**TOWN OF MOUNTAIN VILLAGE
REGULAR DESIGN REVIEW BOARD MEETING
THURSDAY JULY 11, 2019 10:00 AM
2nd FLOOR CONFERENCE ROOM, MOUNTAIN VILLAGE TOWN HALL
455 MOUNTAIN VILLAGE BLVD, MOUNTAIN VILLAGE, COLORADO
AGENDA**

AGENDA ITEM 5
PLANNING & DEVELOPMENT SERVICE
PLANNING DIVISION
455 Mountain Village Blvd.
Mountain Village, CO 81435
(970) 728-1392

Case Summary: The Town of Mountain Village, working with Tom Umbhau of Bauen Group, is requesting Design Review Board (DRB) Final Architectural and Site Review approval to construct two employee apartment buildings at 415 Mountain Village Blvd, Lot 1001R. The two additional buildings would provide a total of 49 new employee apartments and are proposed to be located adjacent to existing apartments within the Village Court Apartment Complex (VCA). In order to secure approval for this project as designed, the applicant is proposing a concurrent application process for Design Review, Density Transfer and Rezone for the creation of an additional 7 units of employee apartment density, and a Variance for the allowed Maximum Building Height. In order to provide clarity, staff will address the two new buildings in the same manner as the applicant and

SHEET No.
L1.03
SCALE: AS SHOWN

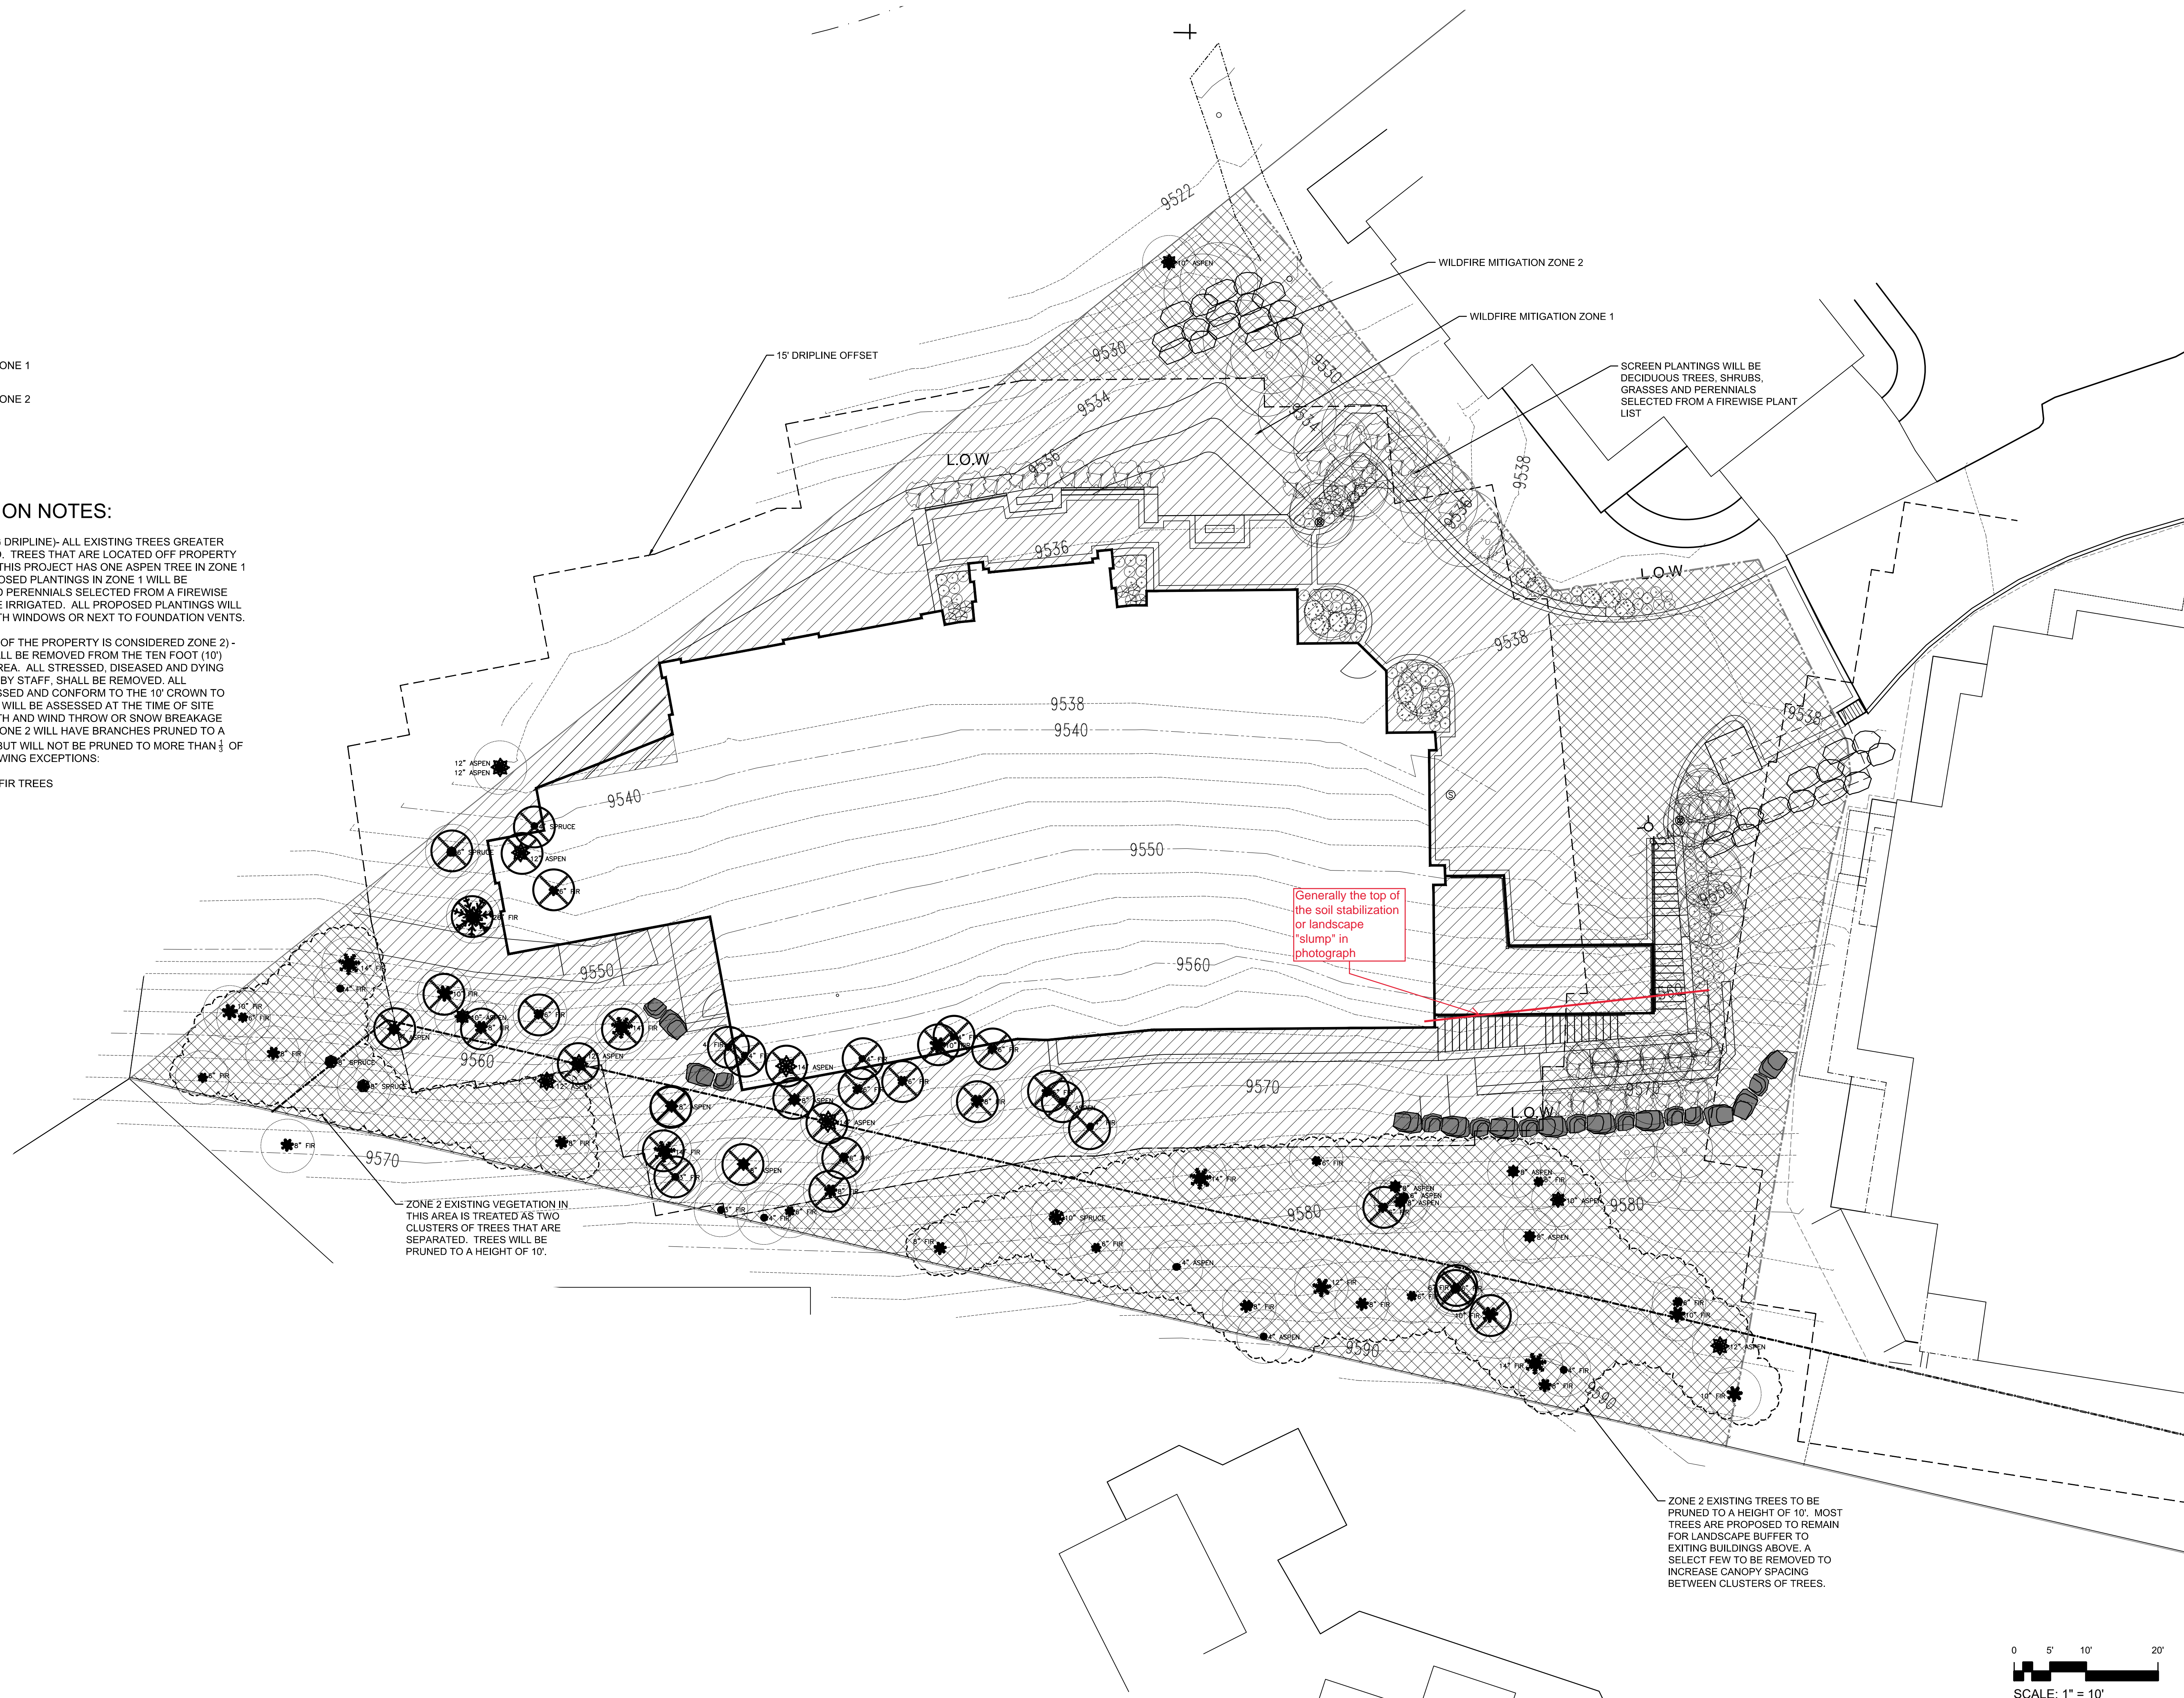
6. Prior to Final Architectural Review, the applicant shall provide a site plan. If they must provide documentation of planning staff review, a forester, arborists, or landscape architect has determined the extent of any thinning work required for forest health. *Wildfire zones are shown on Sheet L1.03.*
